Unapproved minutes P802.3bs 400 Gb/s Ethernet Electrical Ad Hoc Teleconference 29th August 2016

Title: Revisiting MCB/HCB Crosstalk for C2M

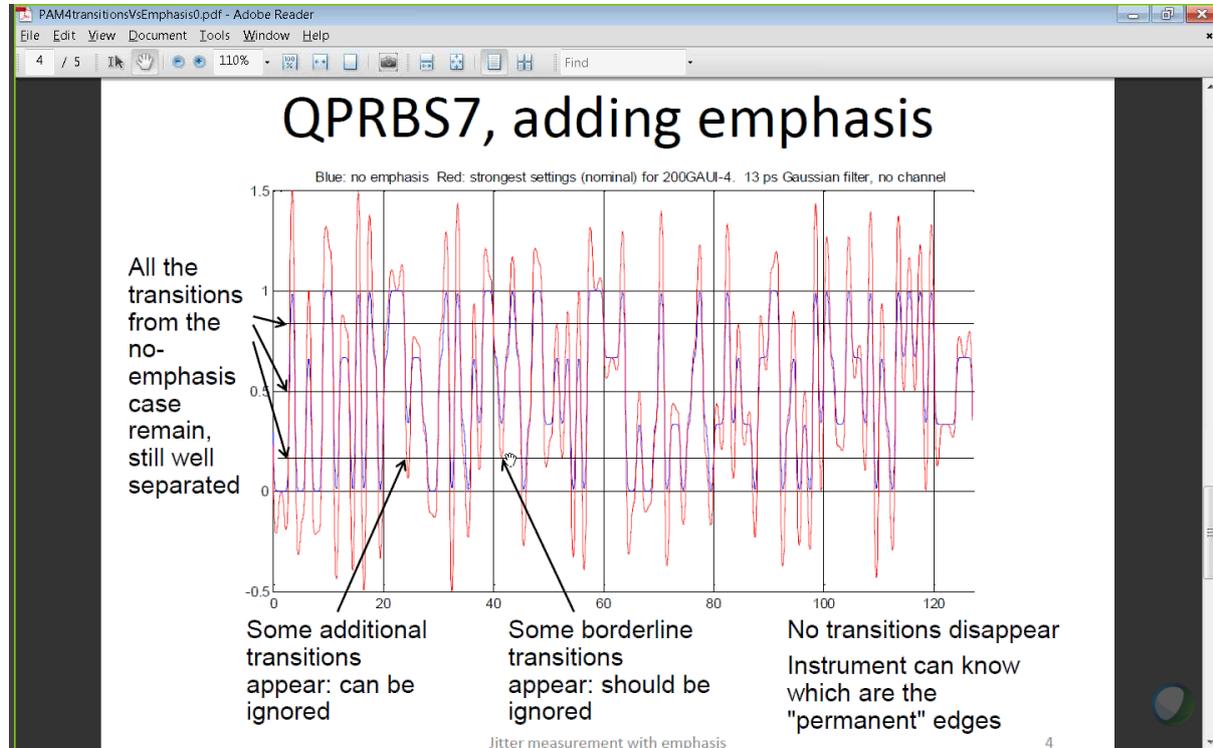
Ali's presentation points out the disparity between the connector crosstalk assumed in previous chip-to-module simulations and the crosstalk of QSFP connectors (Comment #33). He asked that the contributors of those presentations re-run them with additional crosstalk to assess the effect on margin. A related comment by Adam Healey (#33) was mentioned. Andre displayed the comment from the posted D2.0 Comments file: http://www.ieee802.org/3/bs/comments/P802d3bs_D2p0_comments_rec_Cl.pdf It was also pointed out that the posted HCB/MCB models do not include crosstalk, and that it would be helpful if they did.
